Town Council Agenda Meeting

a. AR-08-23 Southern Pines Golf Club Cottages

To: Reagan Parsons, Town Manager
From: Alaina Mallette, Senior Planner
Subject: AR-08-23, Southern Pines Golf Club Cottages, 290 Country Club Circle
Date: September 12, 2023

Figures 4-6. SU-07-22 Screenshots from Exhibit 3 of the SUP Evidentiary Hearing

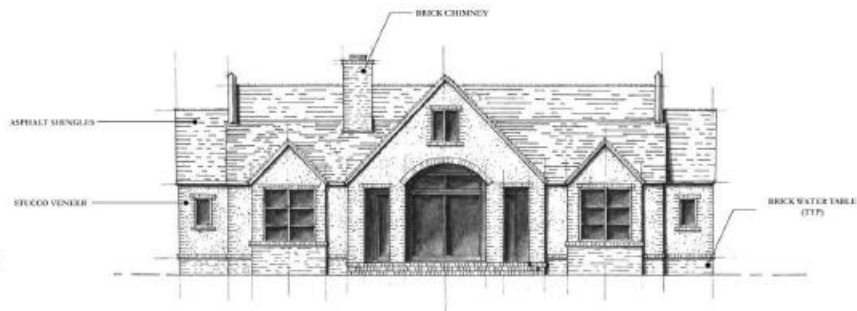
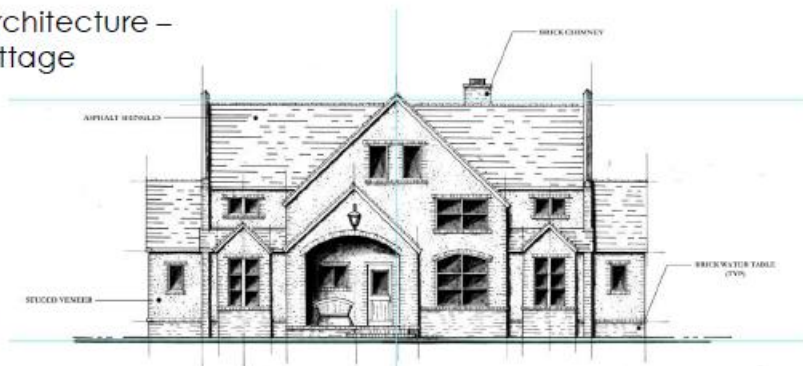
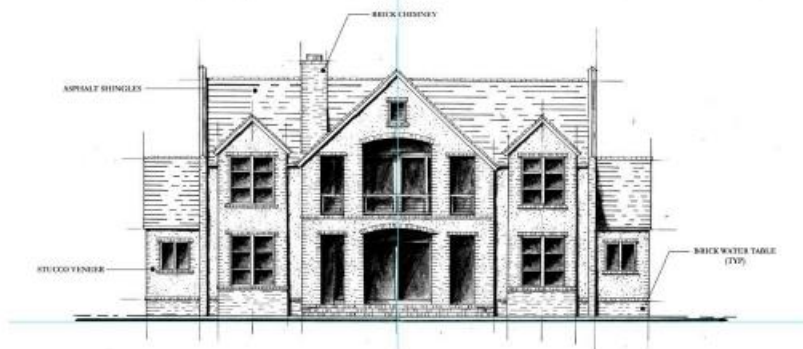
- Condition of approval #9: “The applicant will include variation in the architecture of the units to be constructed. Architectural plans will be presented to the Town Council during the Architectural Compliance Permit Process. To reflect the materials and design of the neighborhood, these units may vary from the strict commercial requirements of Section 4.10.4 of the UDO for materials and design, to permit the units to be constructed with a residential character.” See sample images below from Exhibit 3 of the evidentiary hearing.

VERSION A1 - FRONT ELEVATION
SCALE: 1/8" = 1'-0"

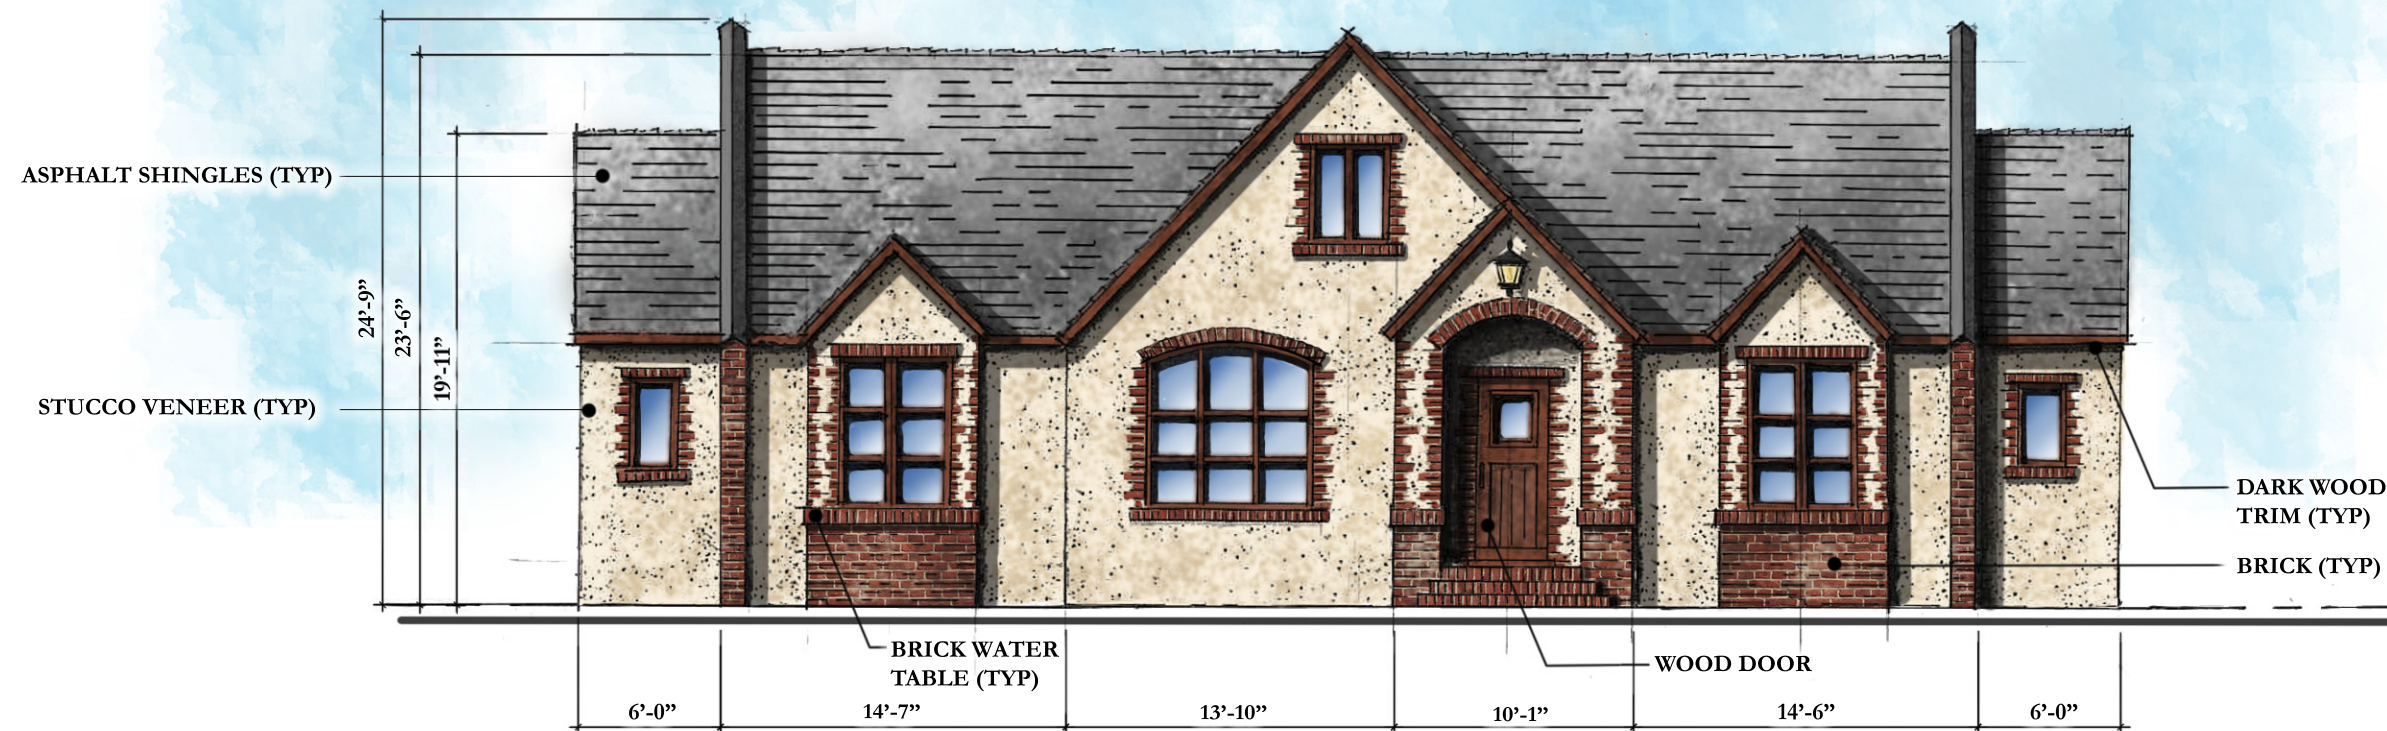
UDO CALCULATIONS	
FACADE:	897 SF
WINDOWS / DOORS:	154 SF (17%)
FACADE MATERIALS:	743 SF
BRICK:	195 SF (26%)

VERSION C1 - FRONT ELEVATION
SCALE: 1/8" = 1'-0"

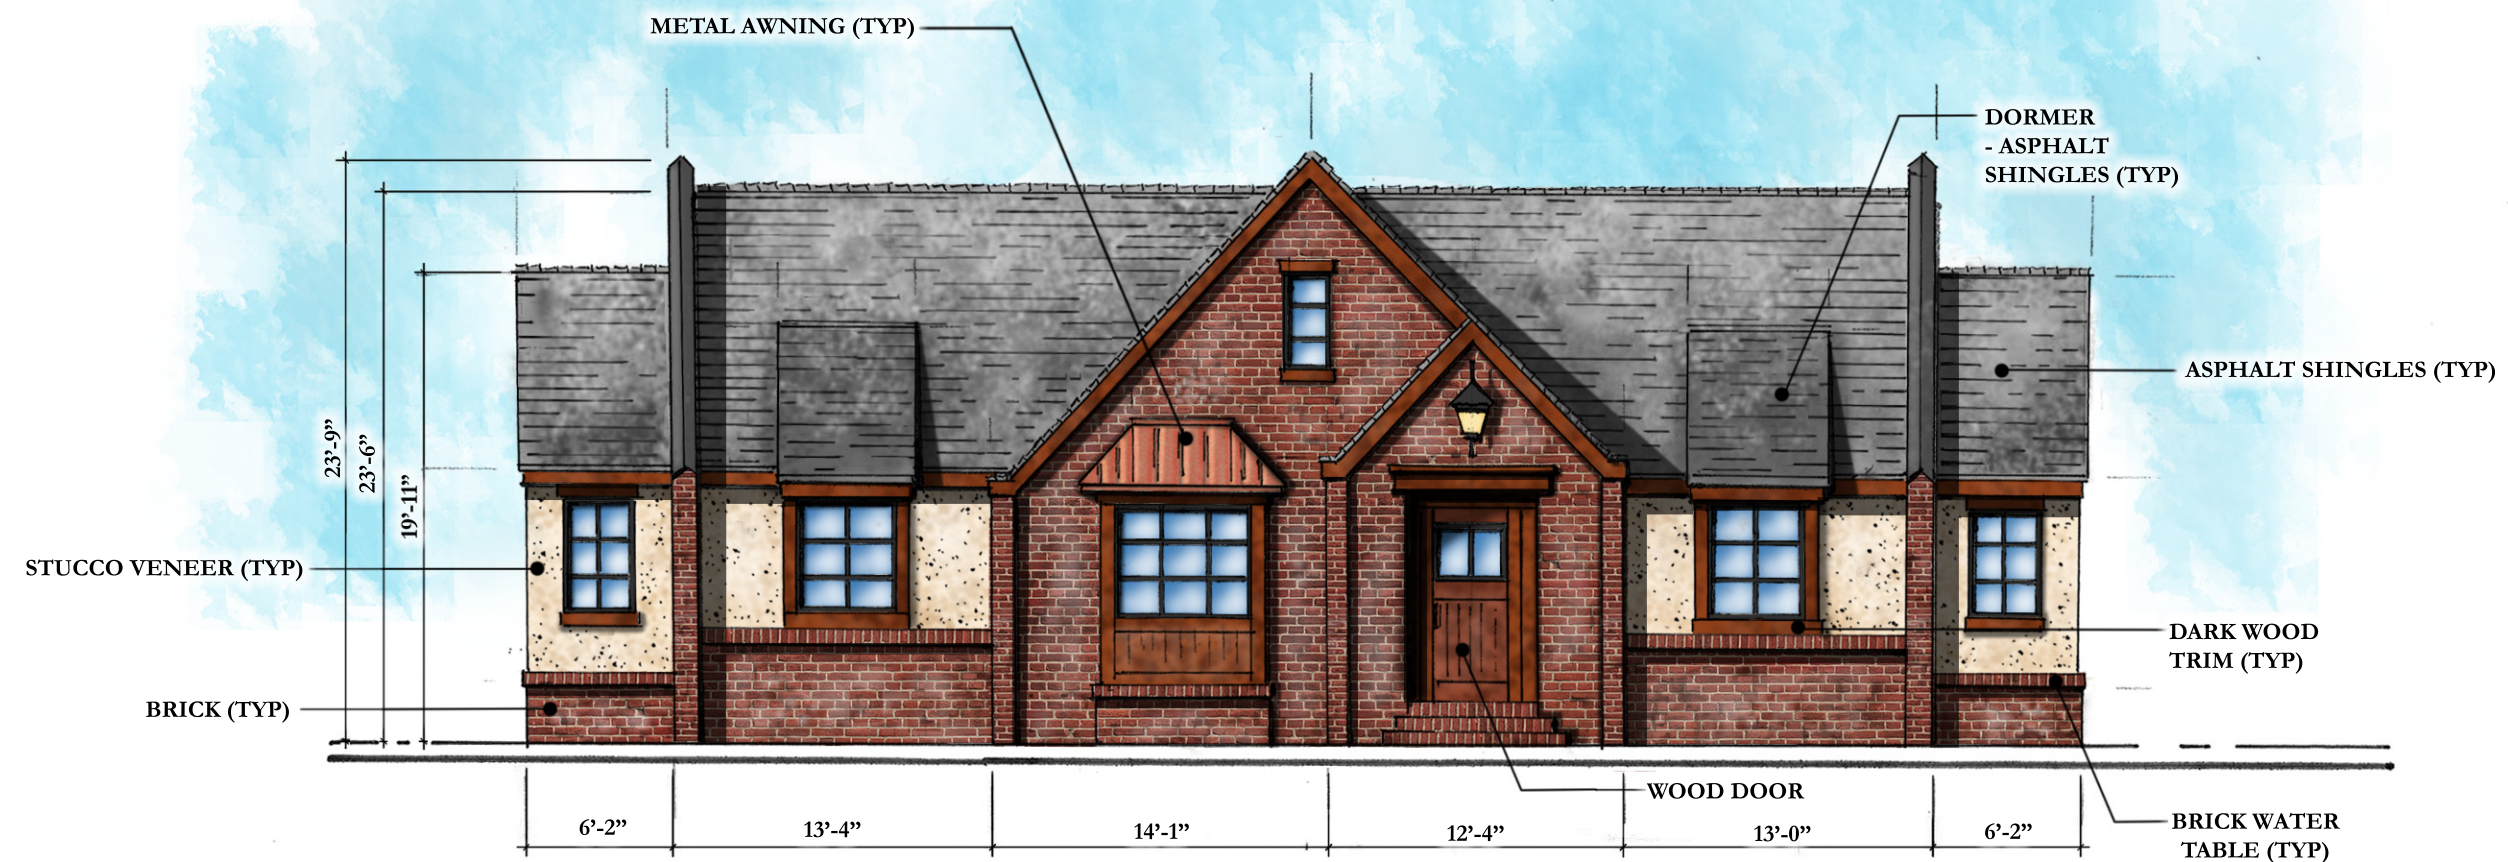
UDO CALCULATIONS	
FACADE:	867 SF
WINDOWS / DOORS:	120 SF (14%)
FACADE MATERIALS:	747 SF
BRICK:	467 SF (63%)

PRELIMINARY
CONCEPTUAL PLAN

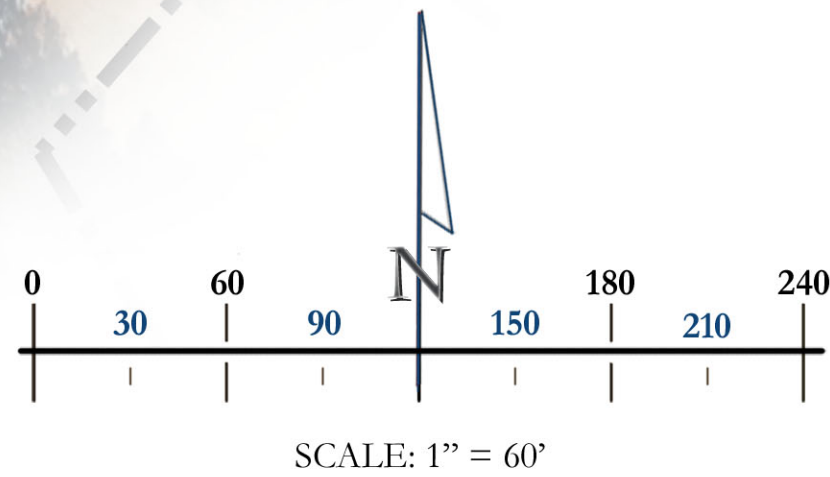
4. Also, just a heads up that condition of approval #11 states that the cottages have a max. of 52 bedrooms, and you're proposing 54-56 bedrooms according to the site plan.

- a. This was a typo in the plan. Please find the attached updated site plan, calling for (7) 4-bedroom cottages and (3) 8-bedroom cottages, totaling 52 bedrooms in total, in compliance with the approved SUP.

(7) 4-BEDROOM COTTAGE:	28 BEDROOMS
(3) 8-BEDROOM COTTAGE:	24 BEDROOMS
TOTAL:	52 BEDROOMS
